FORM APPROVED
OMB NO. 1004-0137
Expires: January 31, 2018**SUNDRY NOTICES AND REPORTS ON WELLS**
Do not use this form for proposals to drill or to re-enter an
abandoned well. Use form 3160-3 (APD) for such proposals.5. Lease Serial No.
NMLC028784C

☒ Oil Well ☐ Gas Well ☐ Other8. Well Name and No.
GRAYBURG DEEP 25 FED 5

** BLM REVISED ** BLM REVISED ** BLM REVISED ** BLM REVISED ** BLM REVISED **

**Permanent Abandonment of Federal Wells
Conditions of Approval (LPC Habitat)**

WELLBORE SKETCH
ConocoPhillips Company -- Permian Basin Business Unit

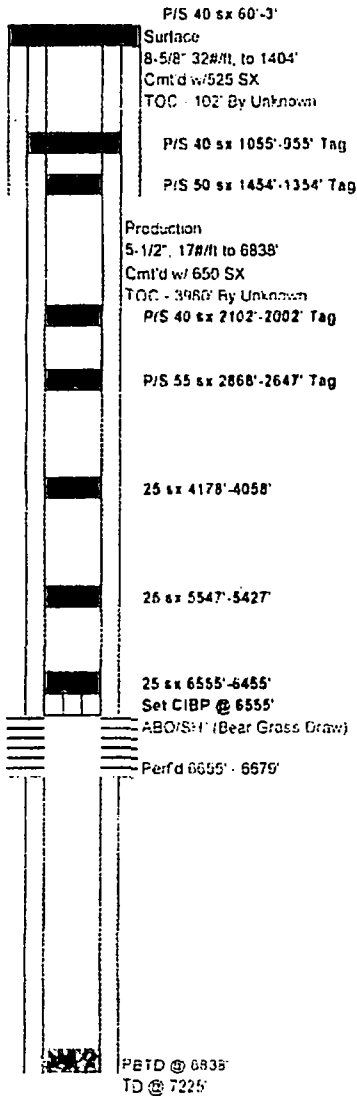
5) Spot 25sx cmt @ 4478' - 4058' 4228' spot 25 SX from 4030-3880. WOC Tag (DVT)

9) Perf & Sqz 40sx cmt @ 1055' - 955'. WOC-Tag 925' - 825' Perf @ 475, 502 cmt to 375. WOC Tag (T-salt)

Below ground level dry hole marker required
